Access Compliance Report

Public Rights-of-Way (Curb Ramps)

Intersection ID: 10016842	Main Street: N_TRYON_ST	Cross Street: N/A	Location: NW
ADA ID: D03388602EBA	Ramp Type: Perp	Initial Pass/Fail: Fail	Overall Compliance: No
		Severity Score: 12.5

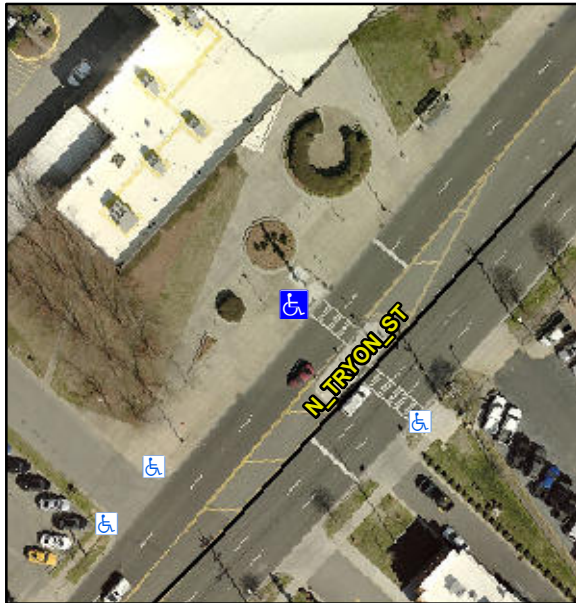
Not Found, R304.2.2

Compliance	Description	Data	Compliance	Description	Data
N/A	Ramp Length (in)	94.0	No	Ramp Slope (%)	8.7
Yes	Ramp Width (in)	59.0	Yes	Ramp XSlope (%)	0.1
N/A	Flare Type LT	N/A	N/A	Flare Type RT	N/A
N/A	Flare Slope LT (%)	N/A	N/A	Flare Slope RT (%)	N/A
N/A	Flare Traversable LT?	N/A	N/A	Flare Traversable RT?	N/A
N/A	Landing Length (in)	N/A	N/A	DWS Provided?	N/A
N/A	Landing Width (in)	N/A	N/A	DWS Contrast?	N/A
N/A	Landing Slope (%)	N/A	N/A	DWS Length (in)	N/A
N/A	Landing X Slope (%)	N/A	N/A	DWS Full Width?	N/A
N/A	Landing Curb? (Y/N)	N/A	N/A	DWS Offset (in)	N/A
N/A	Shared Landing?	N/A			
N/A	Gutter Ponding?	N/A	N/A	Gutter Slope (%)	N/A
N/A	Gutter Lip Ht (in)	N/A	N/A	Gutter X Slope (%)	N/A
N/A	Painted X Walk1?	No	N/A	Painted X Walk2?	N/A
	X Walk 1 Direction	To SE		X Walk 2 Direction	N/A
N/A	X Walk 1 Width (in)	N/A	N/A	X Walk 2 Width (in)	N/A
	X Walk 1 Slope (%)	0.3		X Walk 2 Slope (%)	N/A
	X Walk 1 X Slope (%)	1.4		X Walk 2 X Slope (%)	N/A

Remove & Replace Entire Ramp.
